To: T10 Technical Committee
From: Rob Elliott, HP (elliott@hp.com)
Date: 16 July 2008
Subject: 08-183r1 SAS-2 Add device slot numbering fields to DISCOVER

This proposal is a SAS-2 letter ballot comment.

Figure 1 — Device slot number example using SGPIO

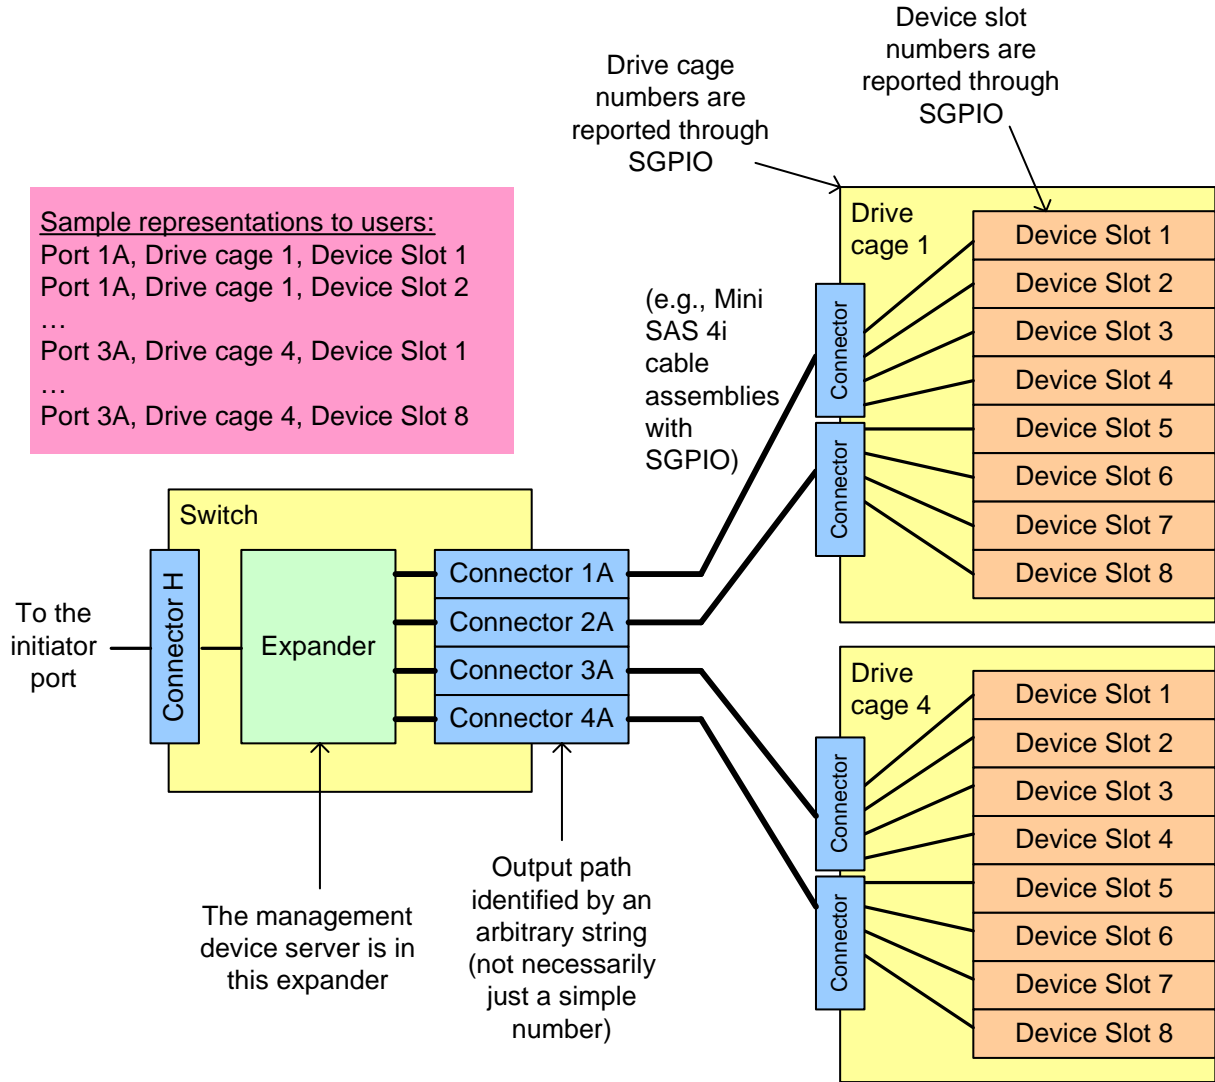
- a) Device Slot Number - a number used to identify the bay (i.e., device slot) within the enclosure. Binary number 0-254 (255 means no number is available). If the device slot is managed by SES, this is the value reported in the DEVICE SLOT NUMBER field in the Additional Element Status diagnostic page. If SGPIO is being used, this is reported over SGPIO.
- b) Device Slot Group Number - a number used to identify the group of device slots. Binary number 0-254 (255 means no number is available). If SGPIO is being used, this is reported over SGPIO.
- c) Device Slot Group Output Connector - a 6-byte ASCII string used to identify the path to the group of device slots (e.g., a switch port number). All ASCII spaces mean no path identifier.

Figure 1 shows an example of device slot numbering in a topology using SGPIO.

Figure 2 — Device slot number example not using SGPIO

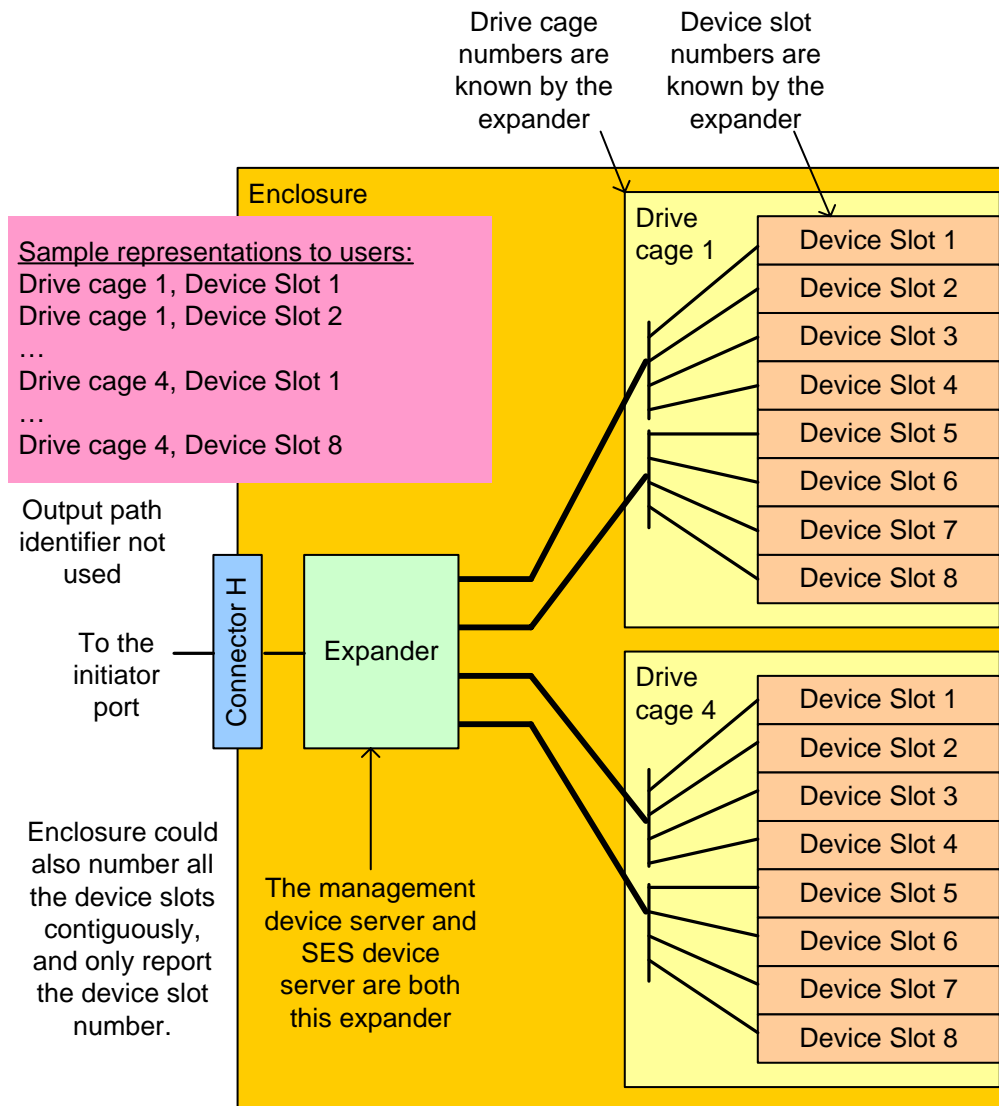
Figure 2 shows an example of device slot numbering in a topology not using SGPIO.
